October 4, 2021

**RE: Transport Housing Apartments
Conceptual Grading and Drainage Plans
Engineer's Stamp Date: 08/25/21
Hydrology File: M15D023H**

**RE: RESPONSE TO HYDROLOGY COMMENTS
TRANSPORT HOUSING APARTMENTS, 2900 TRANSPORT ST. SE
CONCEPTUAL GRADING & DRAINAGE PLAN**

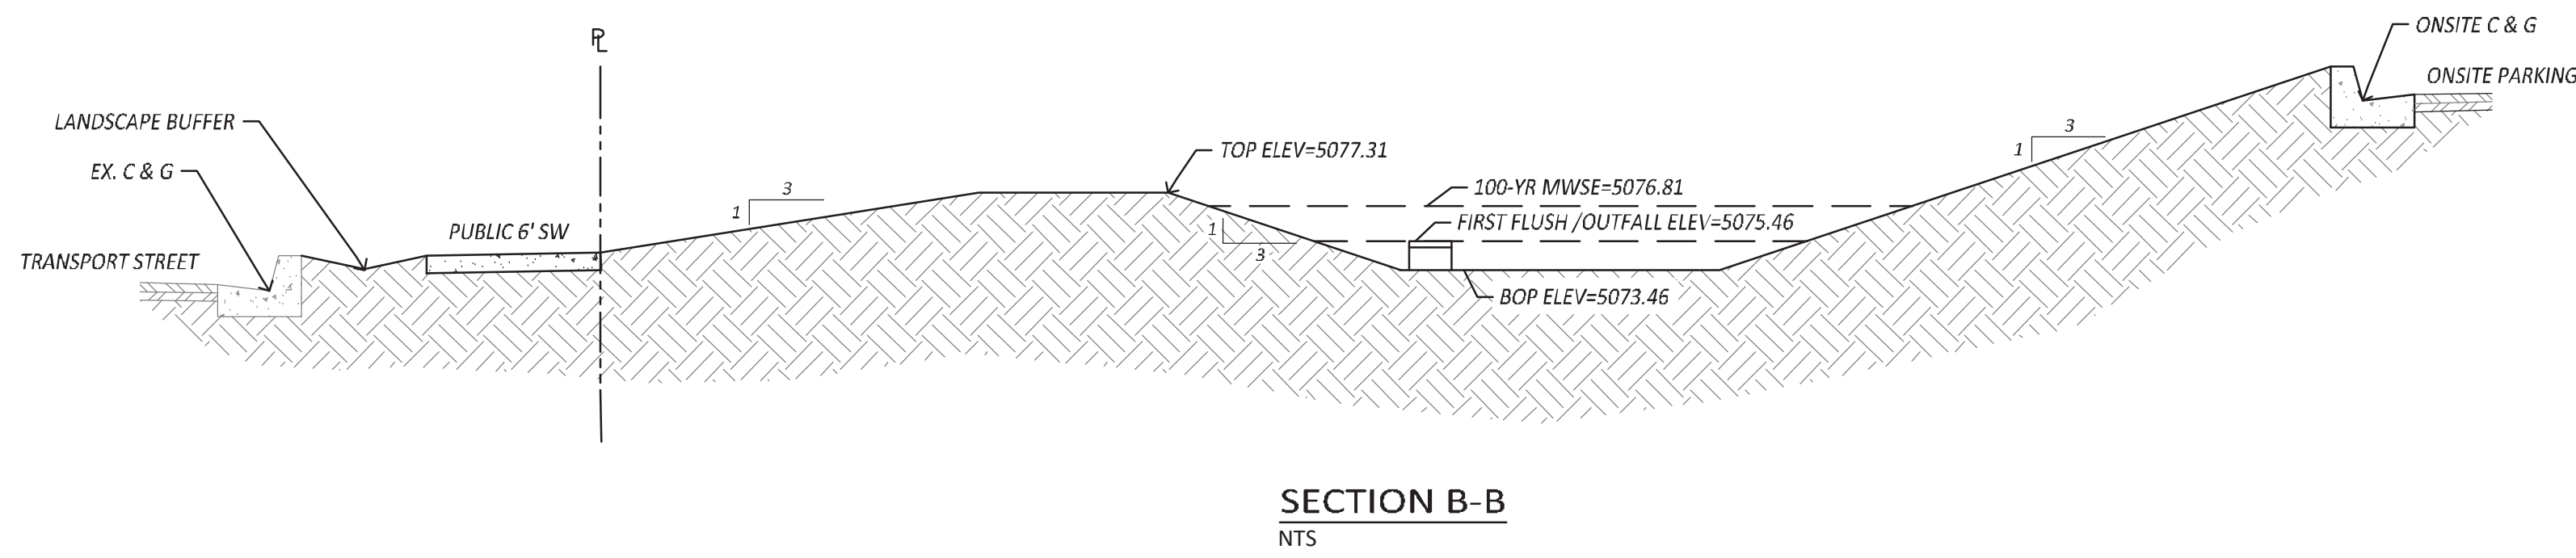
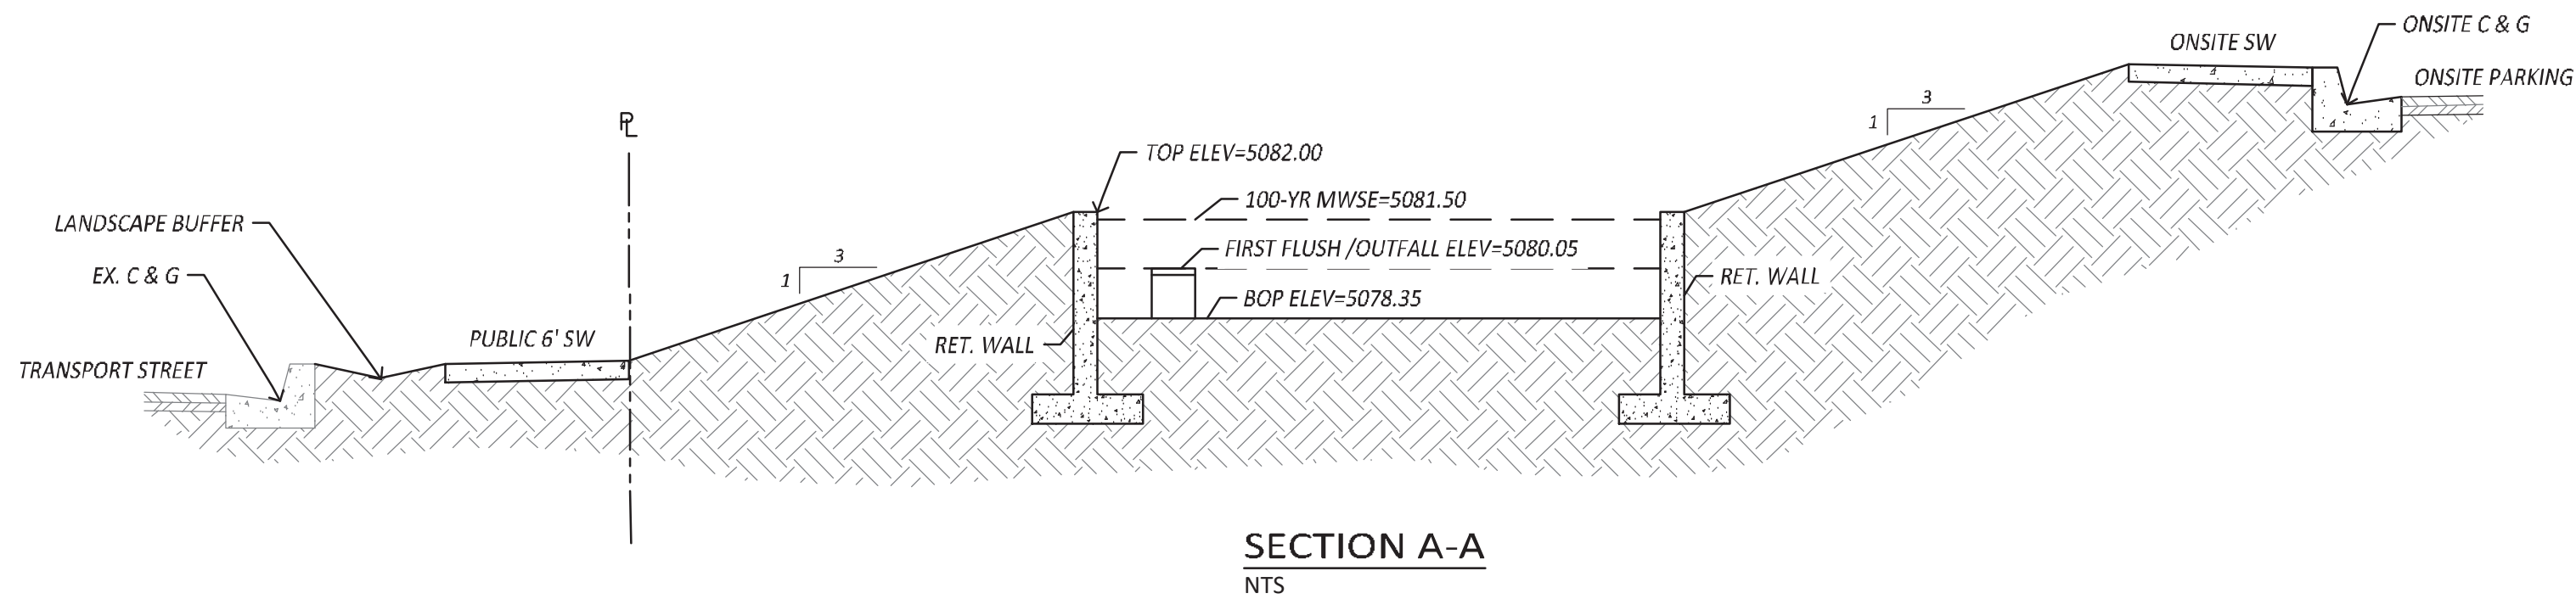
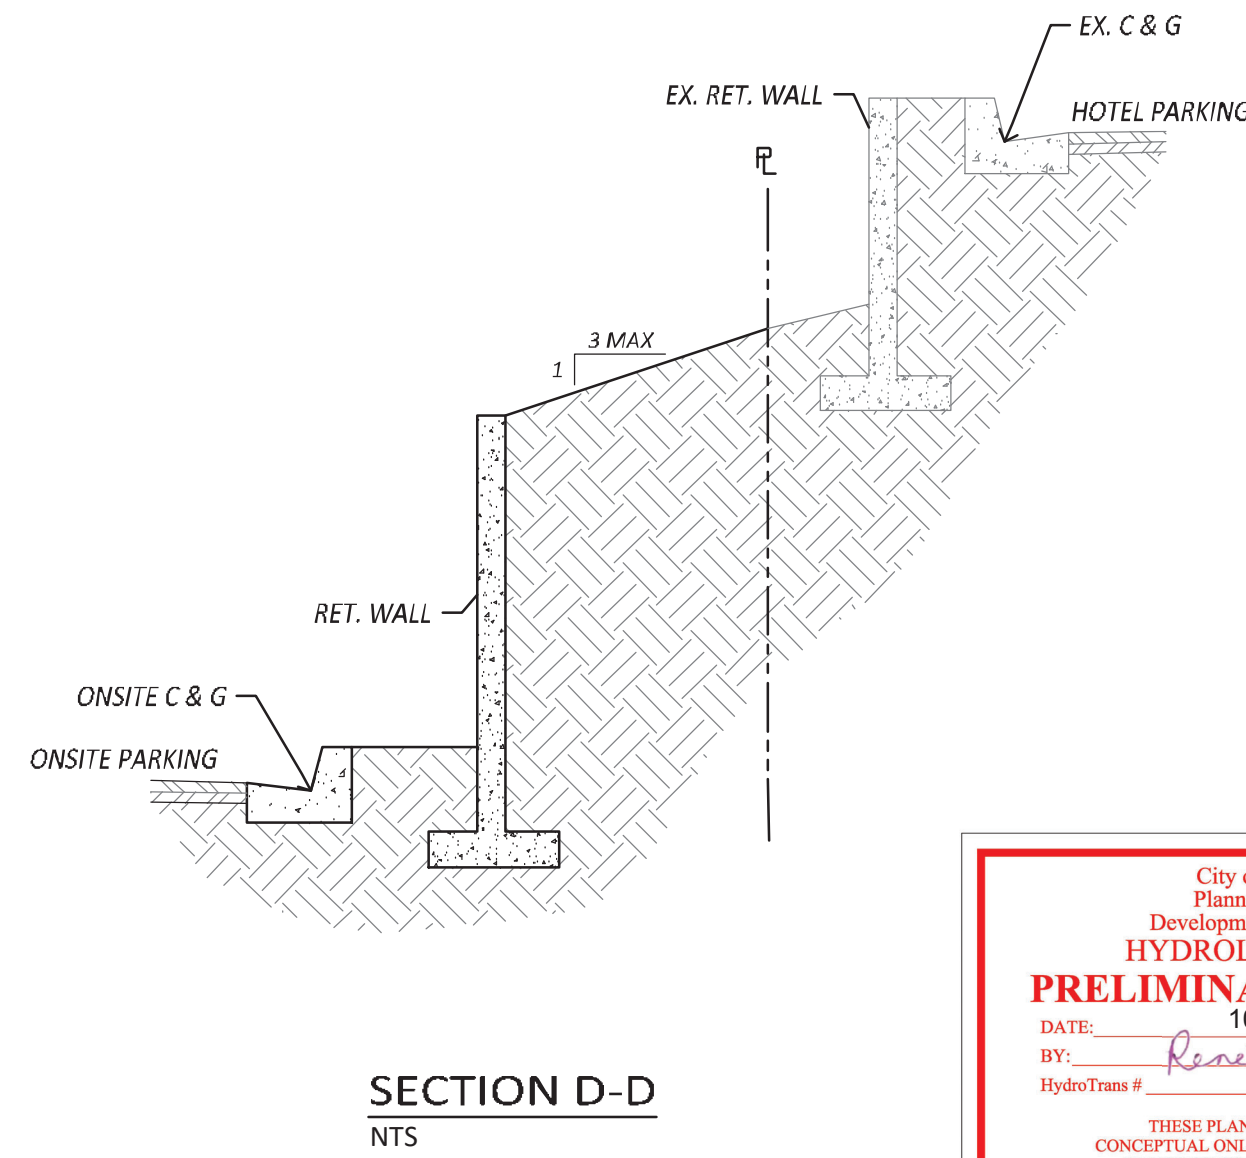
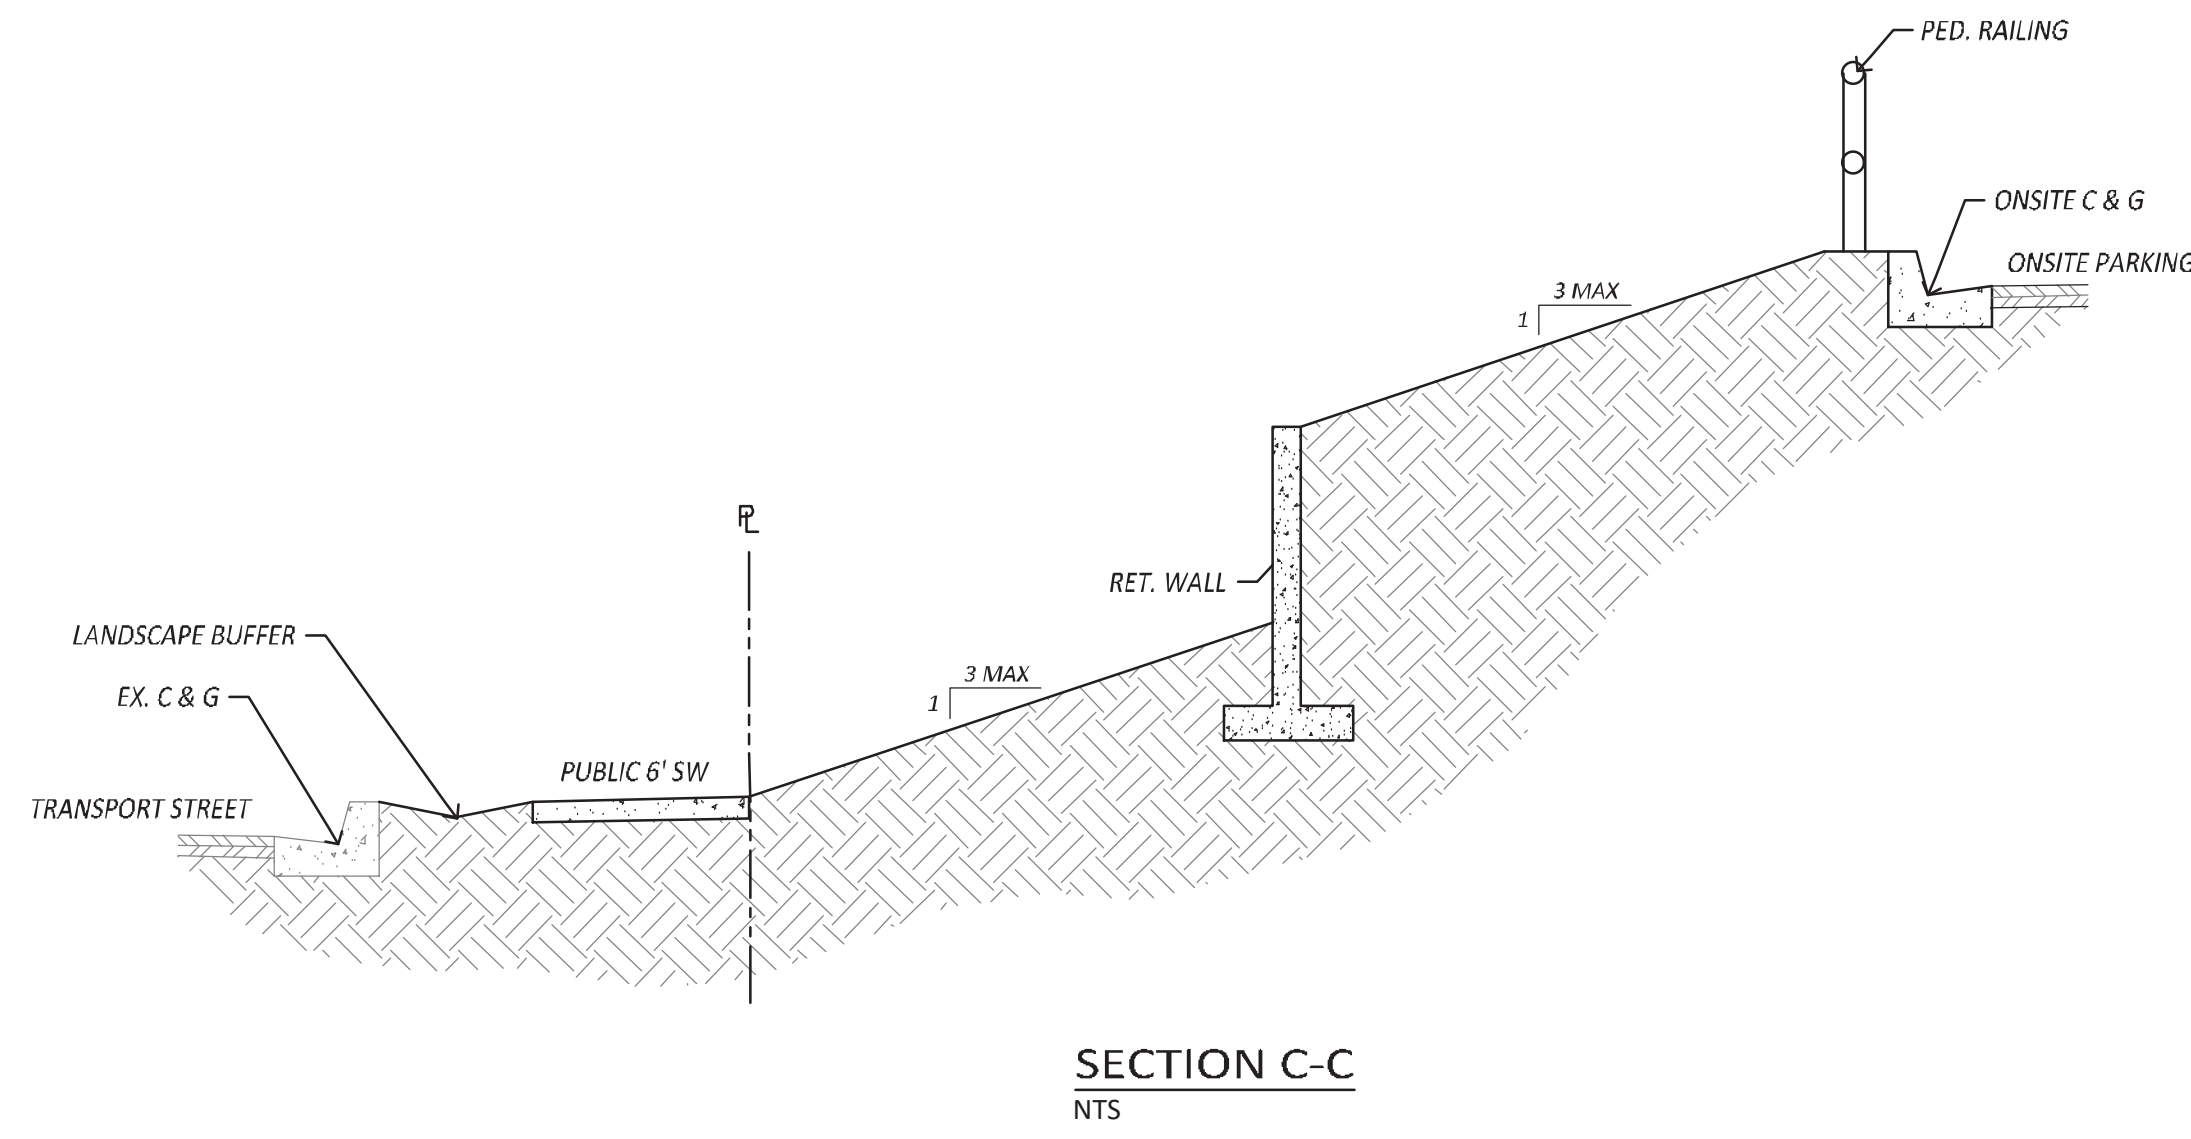
6. Please show a section for each detention pond showing the top of pond elevation, bottom of pond elevation, water surface elevation for the 100 year, water of the stormwater quality, and elevation of the raised outfall pipe.

Response: Sheet 2.3 has been added to show cross sections A-A and B-B for the two ponds. These call out the elevations for the 100yr MWSE, the First Flush/Outfall Elevations, and the BOP/TOP elevations.
